Form Title:	<b>ENGINEERING BULLETIN</b>	Document #:	<b>EB-02-17</b> <small>(Form: DEF-003A-1)</small>
				Revision:
	Document Title:	<b>Wet-R-Dri Valve Product Family Changes and New Product Introduction</b>	Date:	<b>Jun. 2018</b>
				Page:

**Description of Bulletin:** This bulletin provides details on changes to Betts' Wet-R-Dri product line. A new lightweight aluminum handle will be available and will be used in a new metering handle assembly (28981ALEY). A new metering valve will replace the old metering and locking valve. Also, a hydraulic actuated option is now available.

**Part Number Changes:**

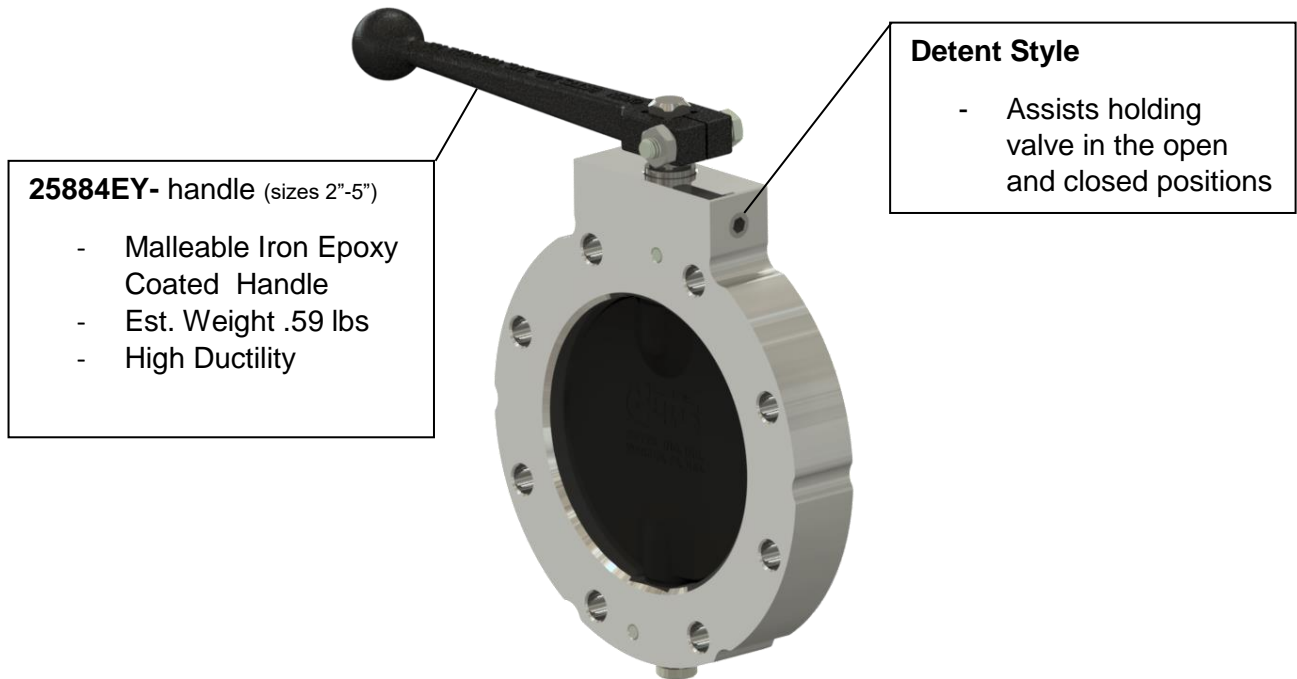
Betts' non-detent WRD models (Model Type 0) are now obsolete and replaced with the detent style models (Model Type 1). Example part numbers shown below.

The detent model has a detent spring and ball which assist in holding the disc in the open and closed position.

**Lightweight Aluminum Handle Option**

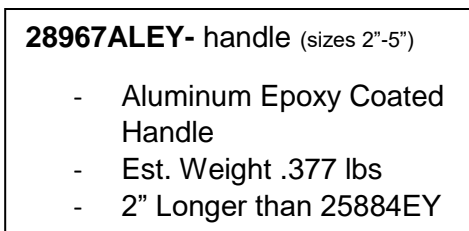
Betts now offers a lightweight longer handle option for valve sizes 2-5". To order a valve with this option add suffix **004** (valve less handle) to the end of the part number and also order 28967ALEY separately.

**Part Number Changes:**

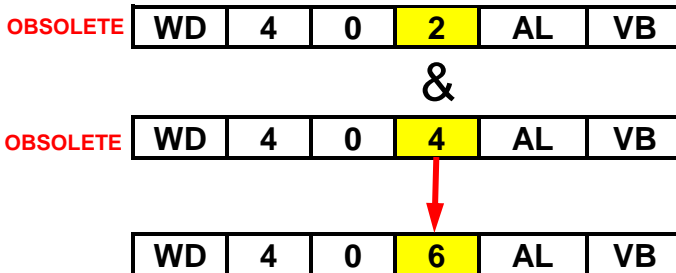
Betts' locking and metering WRD models (Model Type 2 & 4) are now obsolete and replaced with the new 8 position metering model (Model Type 6). The new metering model has a 8 position metering plate with a new lightweight metering handle (Sizes 2-5"). The new lightweight handle is built with less components and is approximately 1.25" shorter than the prior metering handle (sizes 2-5"). Example part numbers shown below.

**8 Position Metering Plate**

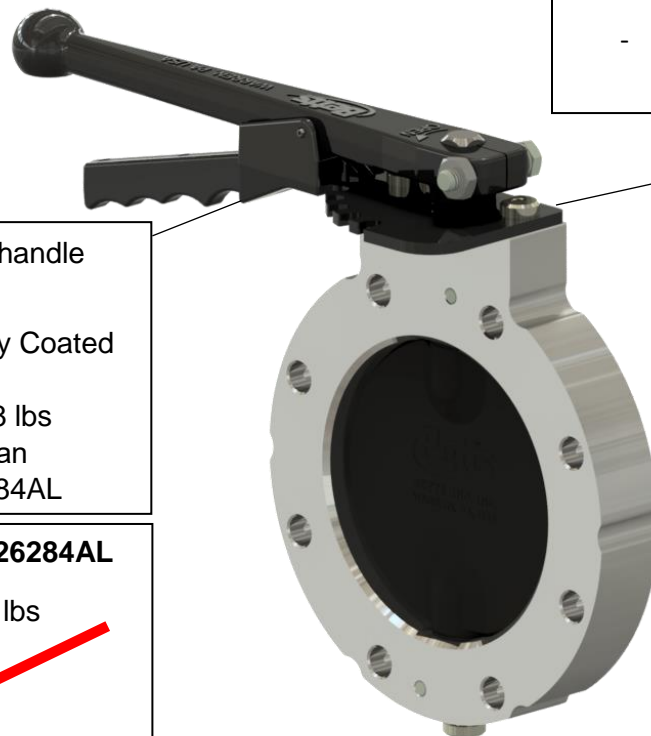
- Allows for 8 different positions

**28981ALEY-** Metering handle assembly (sizes 2"-5")

- Aluminum Epoxy Coated Handle
- Est. Weight .628 lbs
- 1.25" Shorter than 26075AL & 26284AL

**Replaces 26075AL & 26284AL**

- Est weight .939 lbs
